**Riley-Purgatory-Bluff Creek Watershed District**  
Board of Managers Regular Meeting  
**Wednesday, May 5, 2021 Work Session Scheduled 5:00pm Regular Meeting**  
Virtual Meeting via ZOOM  
<https://us02web.zoom.us/j/89539134109>

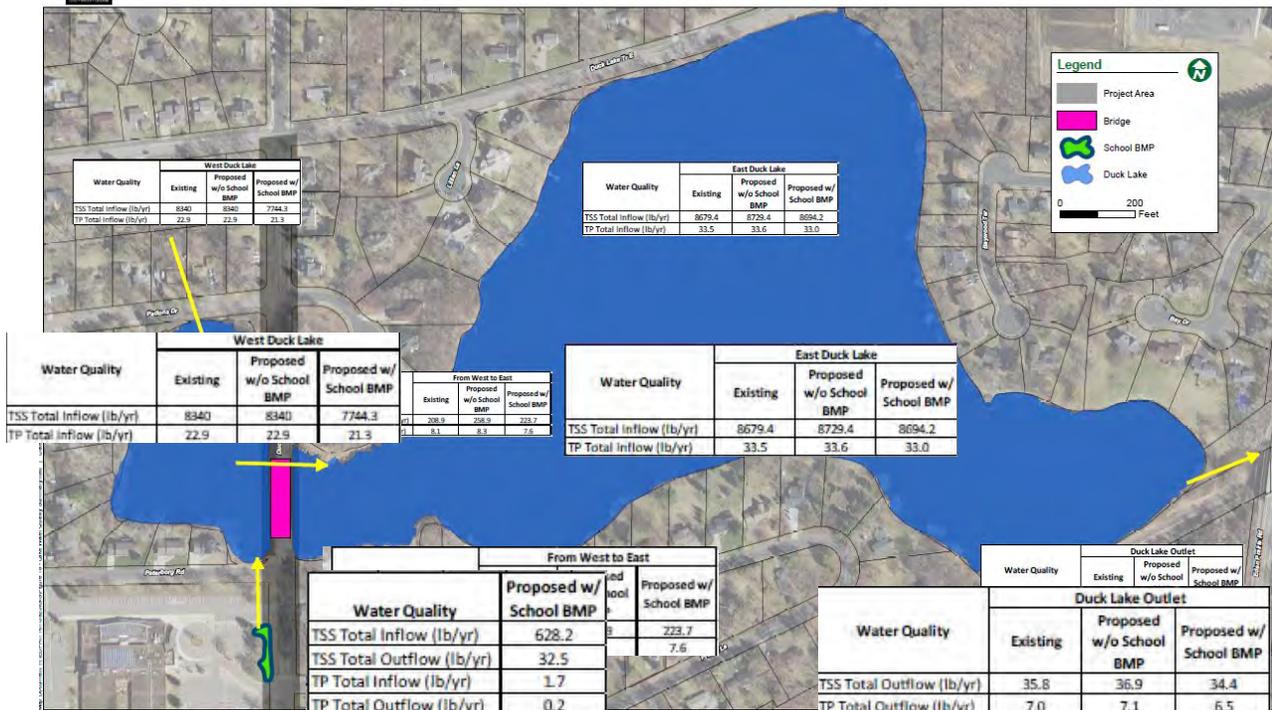
Placement of fill below the 100-year flood elevation is prohibited unless fully compensatory flood storage at the same elevation (+/- 1 foot) and within the floodplain of the same waterbody is provided (Rule B, Subsection 3.2). The supporting materials demonstrate, and the RPBCWD Engineer concurs, that 481 cubic yards of fill will be placed to facilitate the roadway construction, and 497 cubic yards of compensatory storage will be created below the 100-year floodplain by the replacement of the existing roadway embankment with a 237-foot bridge, thus providing a net increase in the floodplain storage and the project conforms to Rule B, Subsection 3.2.

Because filling of floodplain onsite to facilitate roadway construction has the potential to alter the timing and duration of flows leaving the site, the applicant must demonstrate that the alterations are not reasonably likely to have an adverse offsite impact and not reasonably likely adversely affect flood risk, basin or channel stability, groundwater hydrology, stream baseflow, water quality, or aquatic or

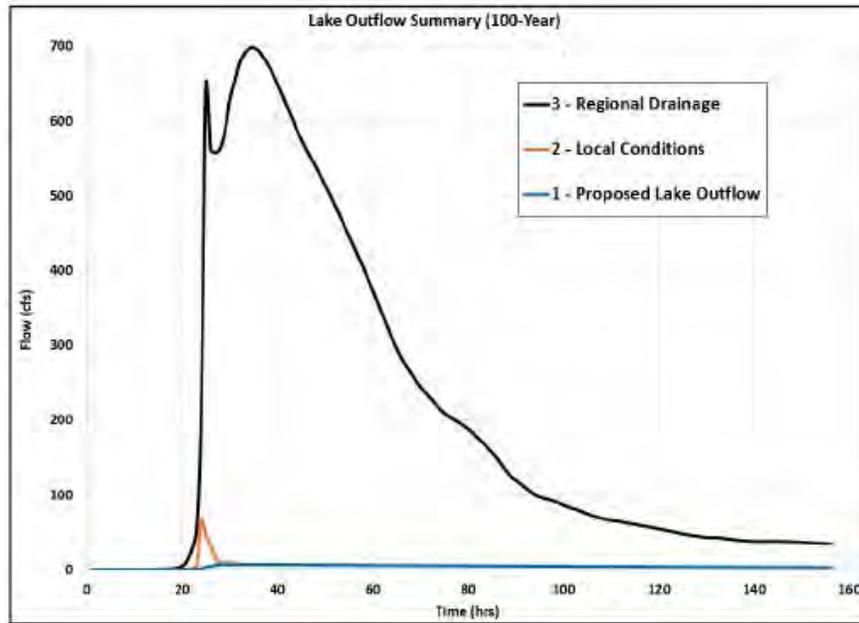
2-year	10-year	50-year	100-Year
Existing Conditions	East Cell Peak Water Elevation (ft)	914.74	915.06	915.77	916.15
	West Cell Peak Water Elevation (ft)	915.32	916.13	916.48	916.53
Proposed Conditions	East Cell Peak Water Elevation (ft)	914.80	915.19	915.83	916.15
	West Cell Peak Water Elevation (ft)	914.80	915.19	915.83	916.15

In addition, the peak flow rate leaving Duck Lake and discharging to Purgatory Creek represents a very small fraction of the discharge in Purgatory Creek (0.6% for the 100-year event), thus constituting a relatively low potential to adversely impact flood elevations and channel stability in Purgatory Creek. The following figure presents an example of this for the 100-year, 24-hour rainfall event. In addition, the 0.1 cfs increase in the 2-year represents about 0.05% of the flow in Purgatory Creek while the 0.3 cfs increase in the 10-year event represents roughly 0.08% of the flow in Purgatory Creek. Also, the restoration of the lake’s normal water level and the construction of the proposed infiltration basin will support additional groundwater recharge. This also supports the engineer’s determination that the project meets the requirements of Rule B, subsection 3.3.
